GENERAL MOTORS  
DCS7216  
URGENT - DISTRIBUTE IMMEDIATELY

Subject: REVISION: N242451390-03 – Service Update  
First Responder Emergency Cut Loop Label Removal  
Revised Parts, Warranty, Service Procedure sections

## N242451390 First Responder Emergency Cut Loop Label Removal

**Revision:** 03

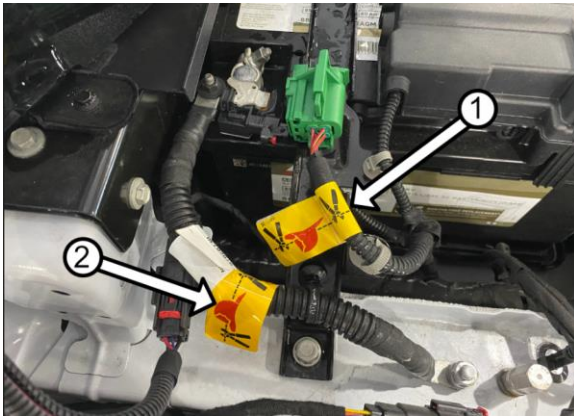
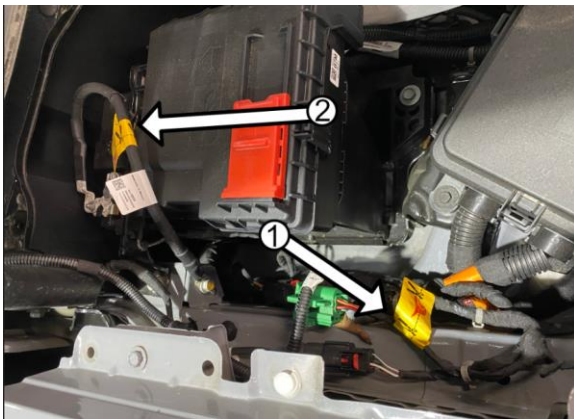
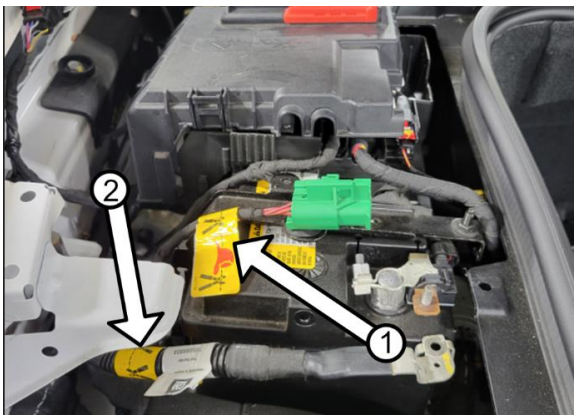
2. Inspect the High Voltage Service Lockout Harness for an Emergency Cut Loop label (1):
  - If the High Voltage Service Lockout Harness has an Emergency Cut Loop label applied (1), proceed to Step 4.
  - If the High Voltage Service Lockout Harness DOES NOT have an Emergency Cut Loop label (1) applied, proceed to Step 3.
3. Install the Emergency Cut Loop label to the High Voltage Service Lockout Harness.
4. Inspect the 12V Battery Negative Cable for an Emergency Cut Loop label (2):
  - If the 12V Battery Negative Cable has the Emergency Cut Loop label applied, proceed to Step 5.
  - If the 12V Battery Negative Cable DOES NOT have the Emergency Cut Loop label applied, proceed to Step 6.

5. Using a sharp cutting tool, remove the Emergency Cut Loop label from the 12V Battery Negative Cable.
6. Install the Right Front Compartment Rear Sight Shield. Refer to *Front Compartment Rear Sight Shield Replacement - Right Side* in SI.
